05-DOE-00565

SUMMARY OF B776/777 RESPONSE TO COMMENTS TO CDPHE

**Decommissioning
Closeout Report
for the
776/777 Closure Project**

Revision 1

Figure 4
Building 776/777
Components Removed
and Remaining

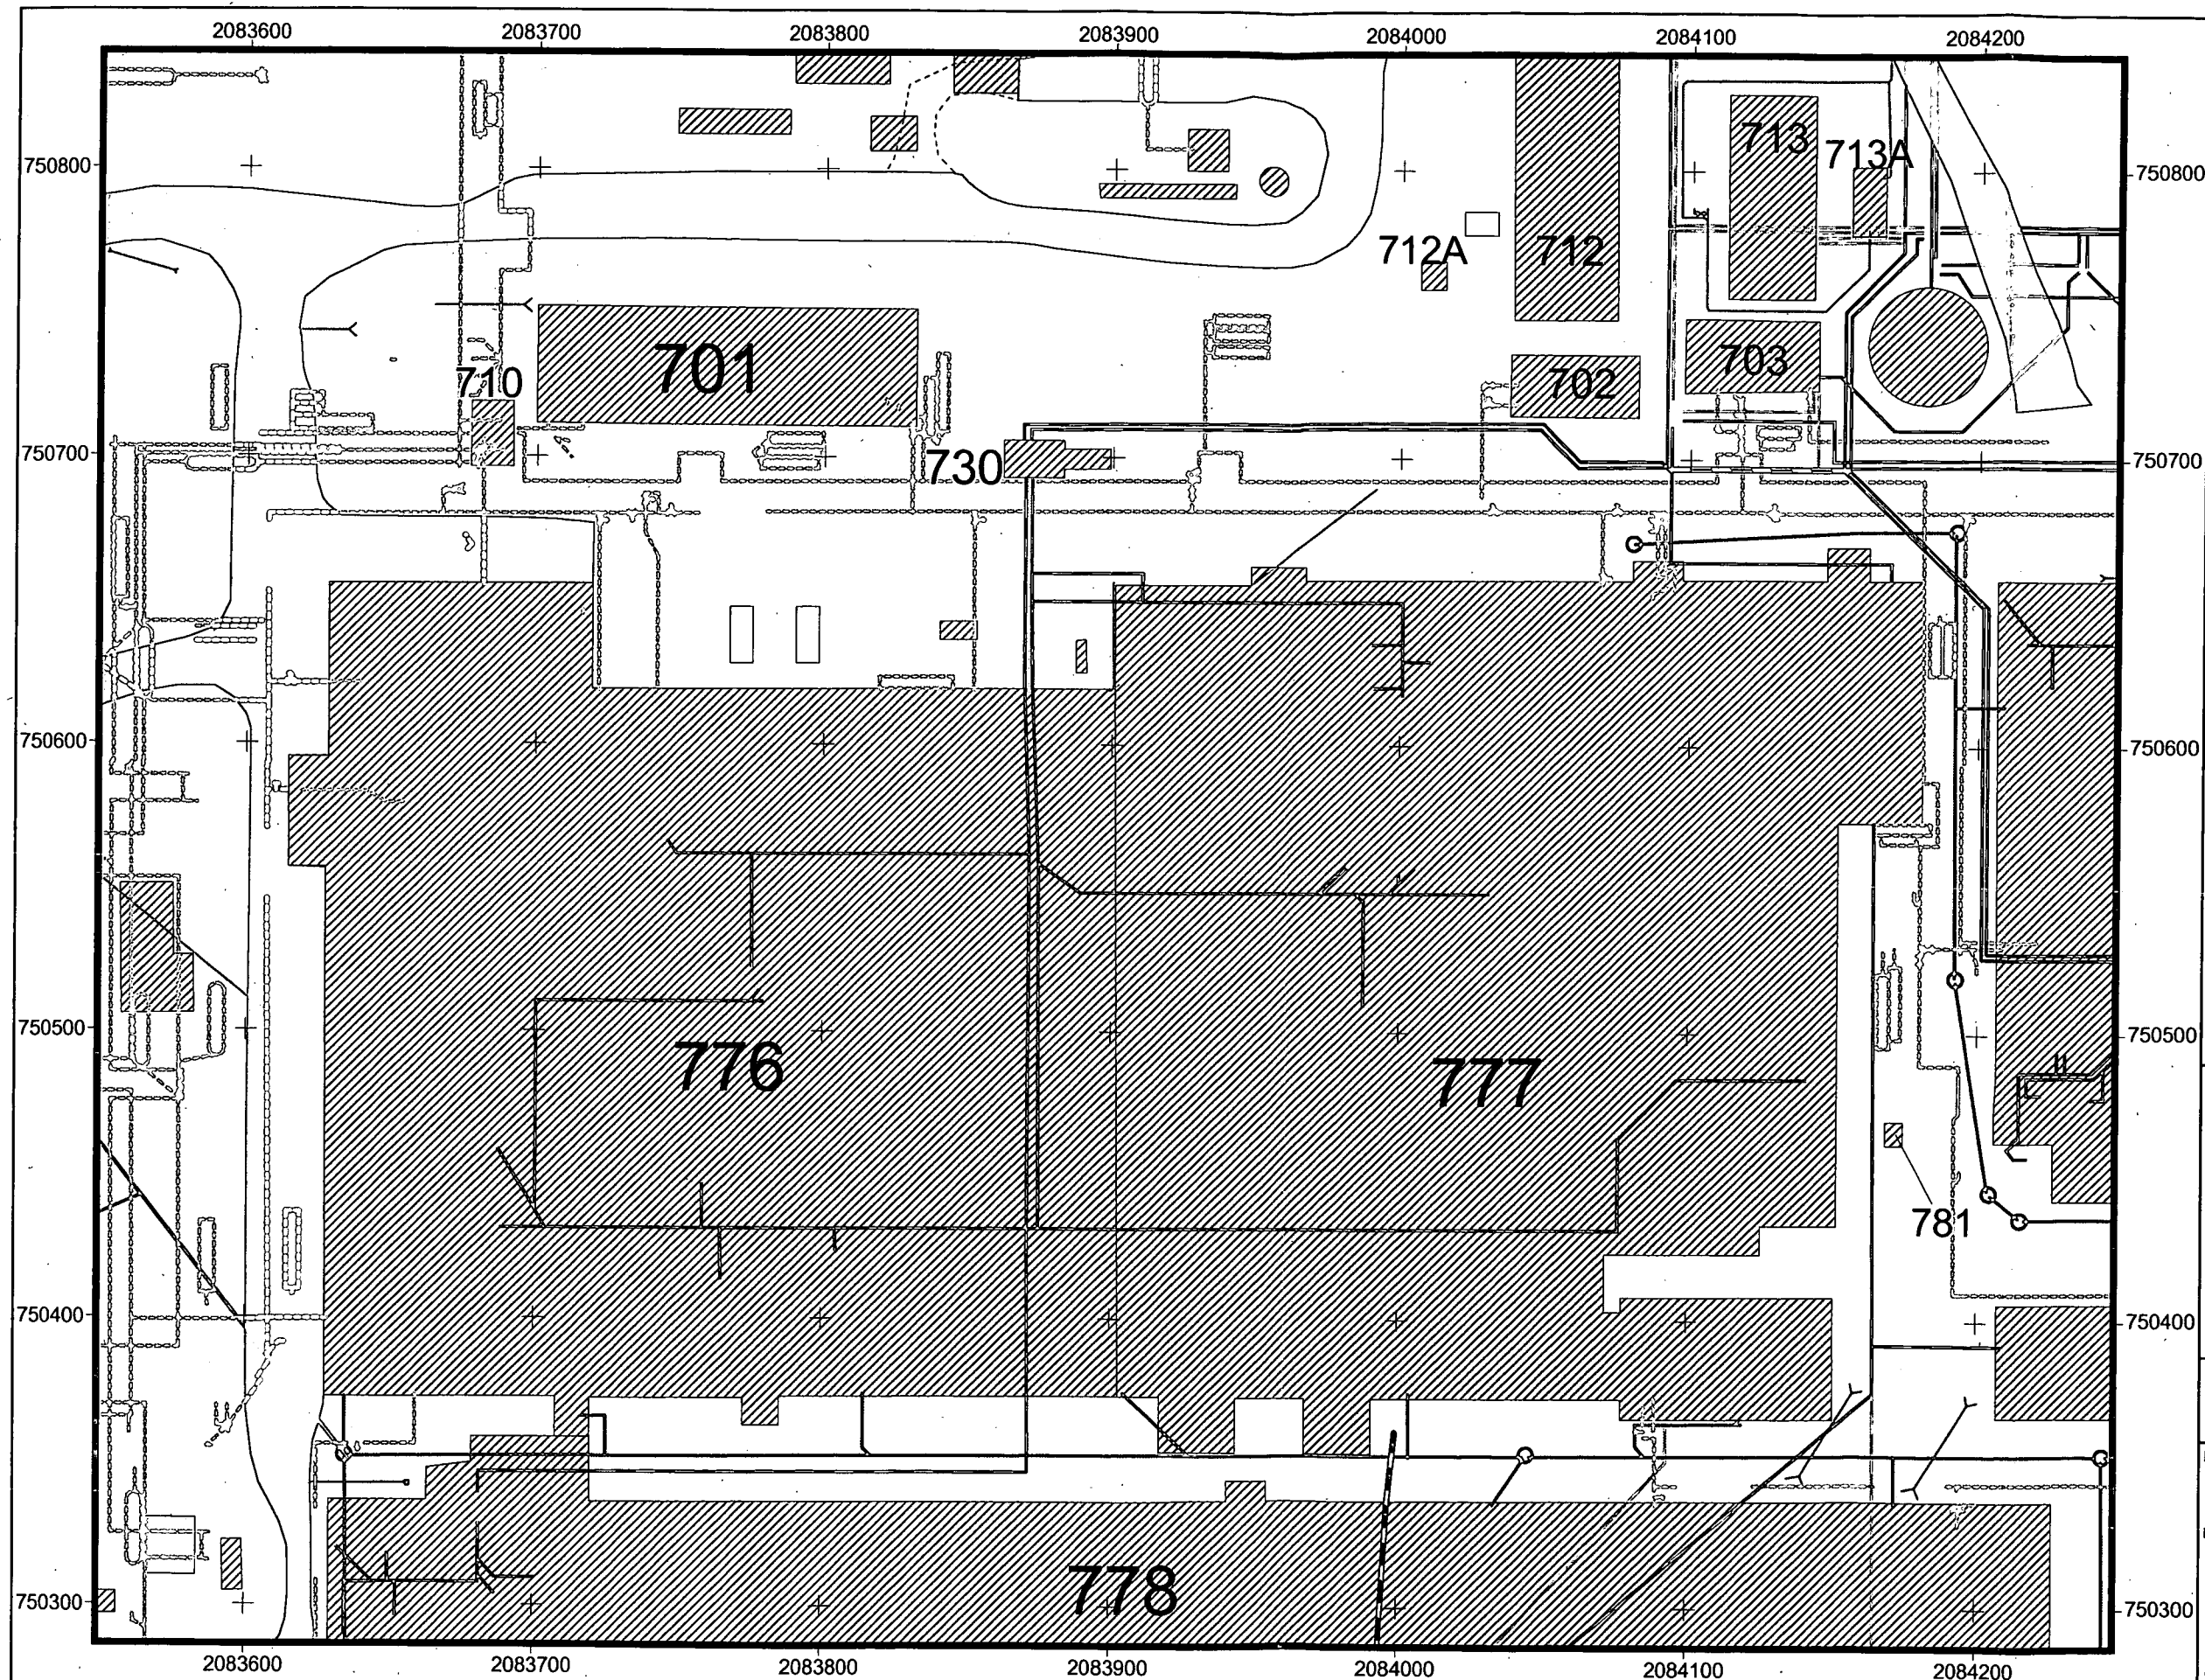
- 5) Figure 4 - What is the difference between demolished structure and removed? This figure should show the outline of the former structures and the location of remaining building structures. In addition this figure and Fig 5 do not appear to agree as to the remaining and removed utilities. Please modify this figure to provide the correct information needed or provide another figure that provides this information.

On Figure 4 there should be no distinction between "demolished structure" and "removed." All structures were demolished and removed, except as previously noted. This figure was being used to show the status of the OPWL, sewer, water and storm drain lines.

Figure 5

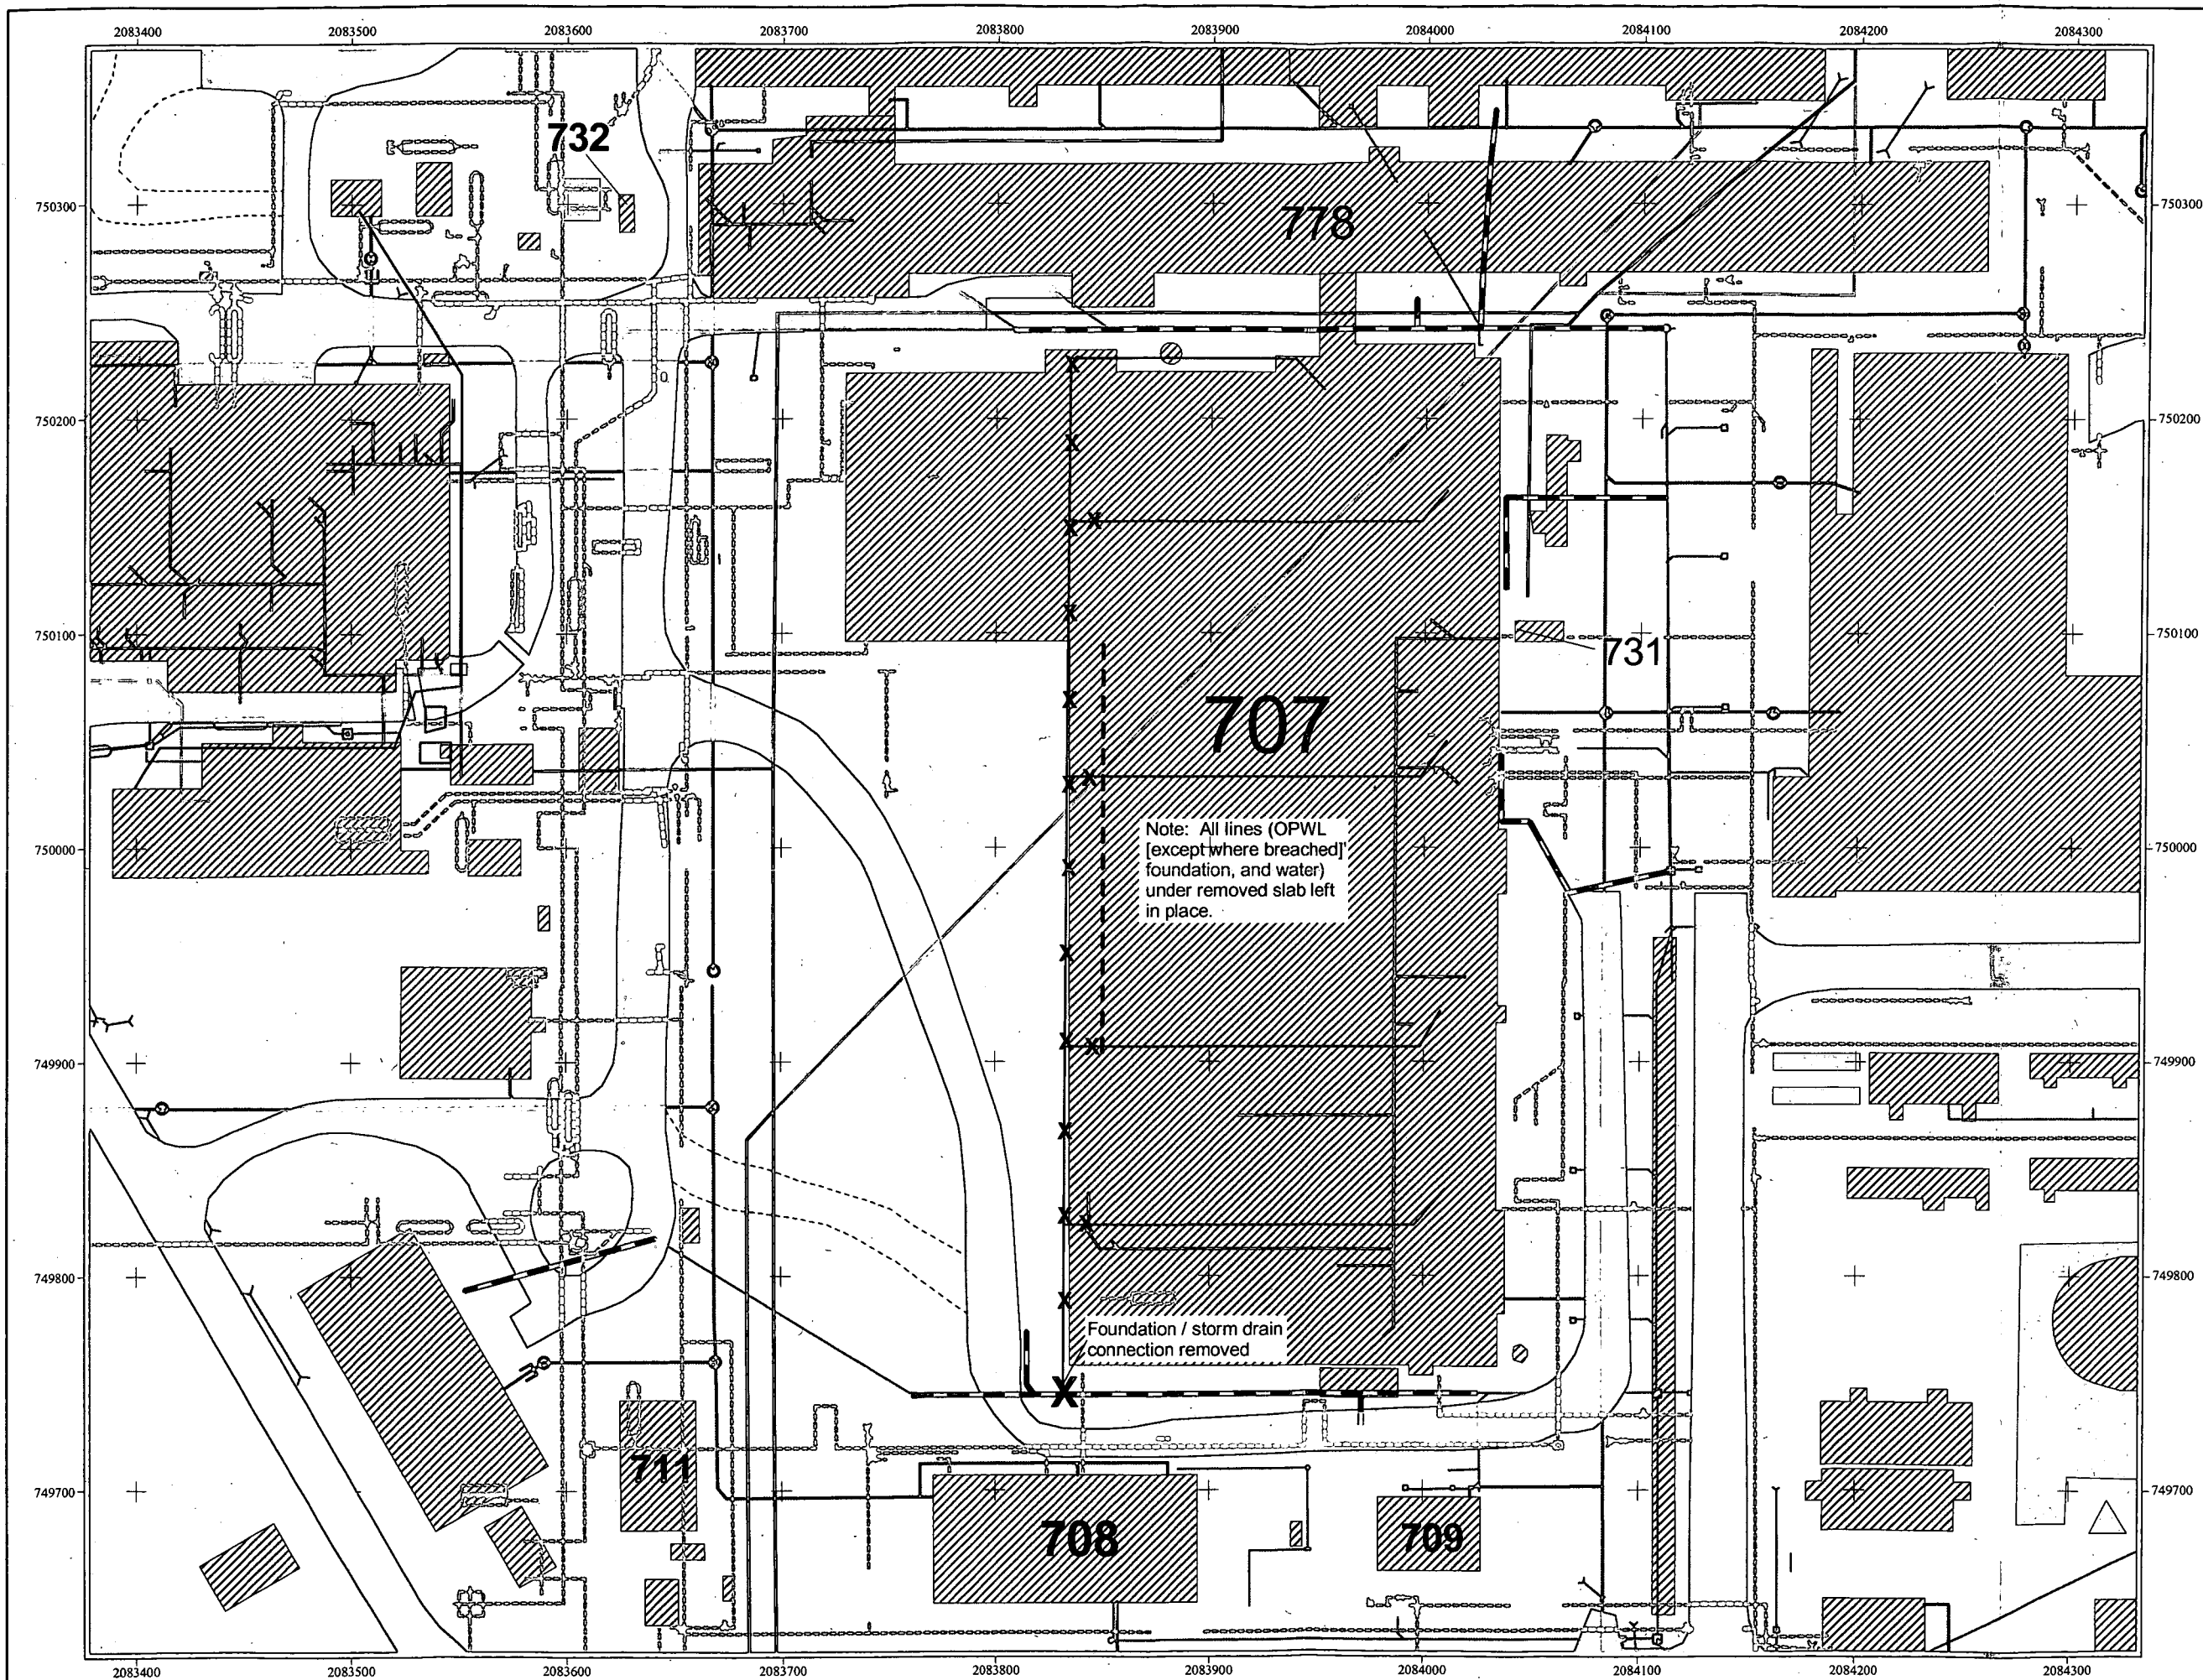
- 7) Figure 5 - This figure does not address the final configuration of the storm drains shown (need to provide a legend for storm drains), nor does it show any foundation drains (although not aware of any foundation drains associated with B776/777) as discussed in this document (2nd paragraph Section 5).

The status of storm drains are shown on Figure 4.
